### ADDENDUM NO. 1

**RE: Item #4, March 20, 2019 Letting - NH 0012(207)248, PCN 05E2, Edmunds County - Cold Milling Asphalt Concrete, Asphalt Concrete Resurfacing, & Culvert Repair**

Published Date: 1st Qtr. 2019	S D D O T	EMBANKMENT, SURFACING, AND PAYMENT LIMITS FOR MGS TANGENT END TERMINAL	PLATE NUMBER 630.89
			Sheet 1 of 2

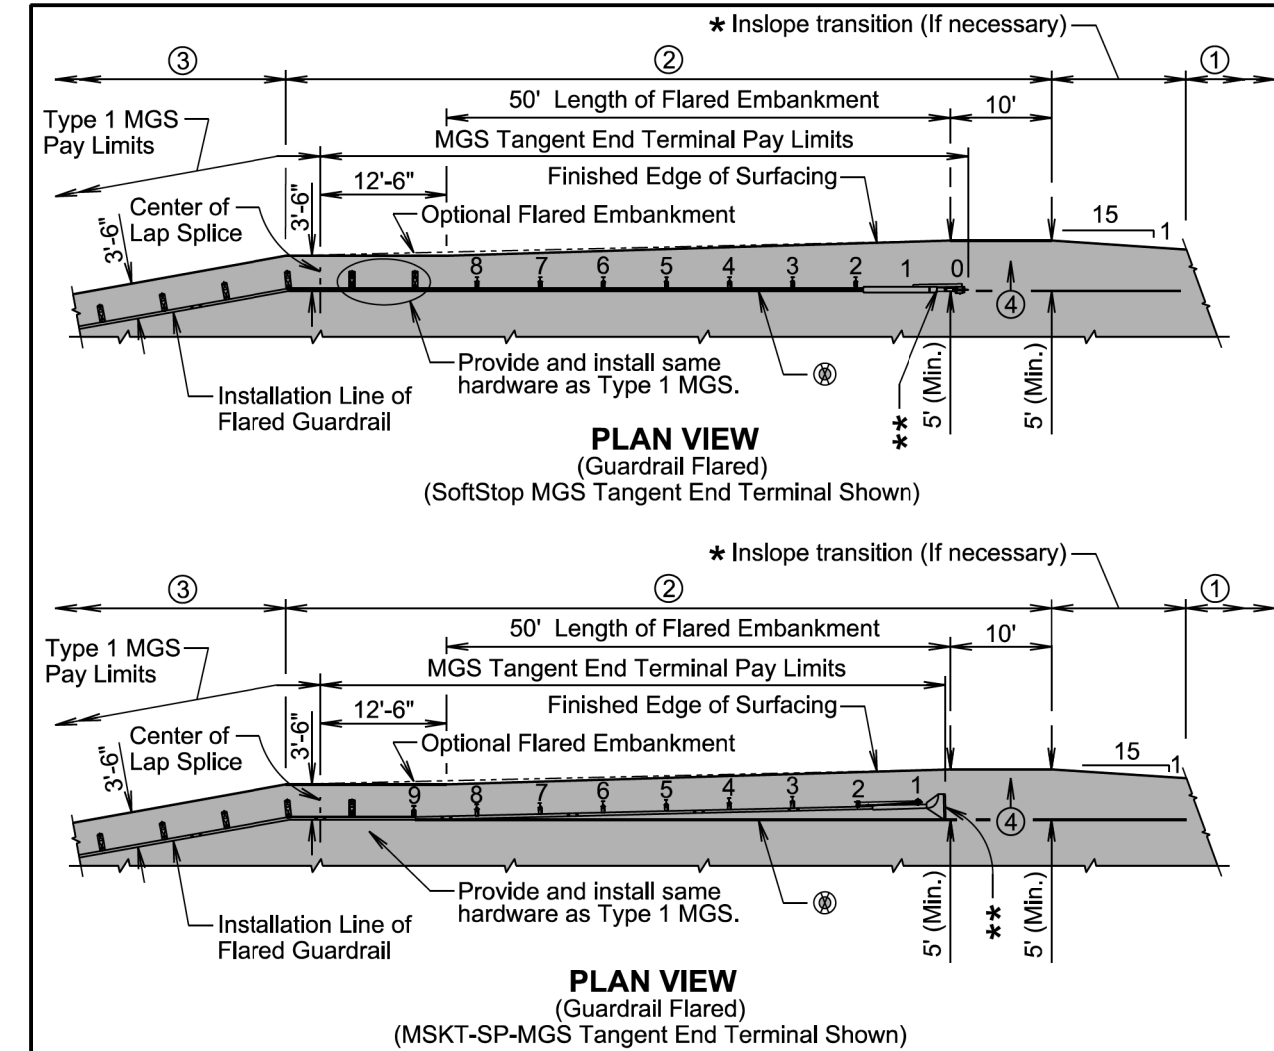
**Sheets 52 and 53:** **PEN AND INK CHANGE:** please change all references from 630.88 to 630.89

**Sheet 71A:** Standard Plate 630.89 was added.
